Access Compliance Report Public Rights-of-Way (Curb Ramps)

Intersection ID: 10038838	Main Street: STEELECROFT_PY	Cross Street: N/A	Location: N
ADA ID: FC6985B4E6CF	Ramp Type: PerpDiag	Initial Pass/Fail: Fail	Overall Compliance: No Severity Score: 22.5

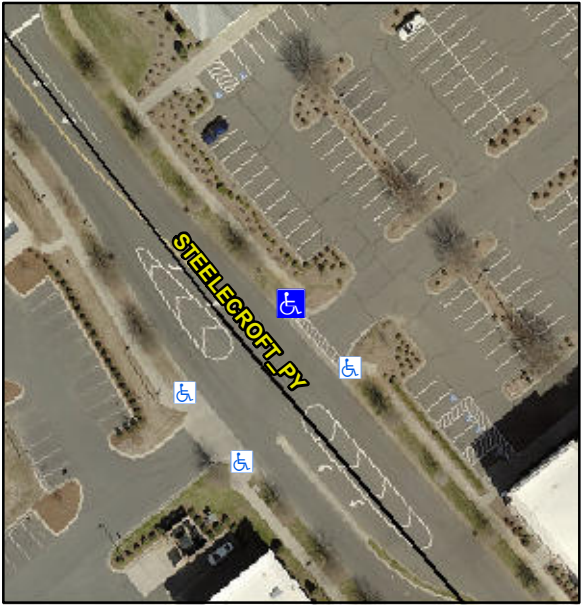
PROW/ADA:
Not Found, R304.5.1, R304.2.2, R304.5.3

Compliance	Description	Data	Compliance	Description	Data
N/A	Ramp Length (in)	102.0	No	Ramp Slope (%)	8.7
No	Ramp Width (in)	38.0	No	Ramp XSlope (%)	3.7
N/A	Flare Type LT	N/A	N/A	Flare Type RT	N/A
N/A	Flare Slope LT (%)	N/A	N/A	Flare Slope RT (%)	N/A
N/A	Flare Traversable LT?	N/A	N/A	Flare Traversable RT?	N/A
N/A	Landing Length (in)	N/A	N/A	DWS Provided?	N/A
N/A	Landing Width (in)	N/A	N/A	DWS Contrast?	N/A
N/A	Landing Slope (%)	N/A	N/A	DWS Length (in)	N/A
N/A	Landing X Slope (%)	N/A	N/A	DWS Full Width?	N/A
N/A	Landing Curb? (Y/N)	N/A	N/A	DWS Offset (in)	N/A
N/A	Shared Landing?	N/A			
N/A	Gutter Ponding?	N/A	N/A	Gutter Slope (%)	N/A
N/A	Gutter Lip Ht (in)	N/A	N/A	Gutter X Slope (%)	N/A
N/A	Painted X Walk1?	No	N/A	Painted X Walk2?	Yes
	X Walk 1 Direction	To E		X Walk 2 Direction	To SE
N/A	X Walk 1 Width (in)	N/A	N/A	X Walk 2 Width (in)	52.0
	X Walk 1 Slope (%)	0.7		X Walk 2 Slope (%)	0.2
	X Walk 1 X Slope (%)	0.6		X Walk 2 X Slope (%)	3.5

N/A	Ramp inside XWalk1?	N/A	N/A	Ramp inside XWalk2?	Yes
	Road Slope (%)	3.0	N/A	Clear Space?	N/A
	Road X Slope (%)	1.8	N/A	Clear Space to XWalk (in)	N/A
N/A	Any Obstructions?	N/A	N/A	Storm Grate/Utility Hazard?	N/A
	Obstruction Type			Storm Grate/Utility Type	
			N/A		N/A
			Yes	Surface Condition? (G/P)	Good

Possible Solutions:
Remove & Replace Curb Ramp With Two New Directional Ramps or Equivalent.
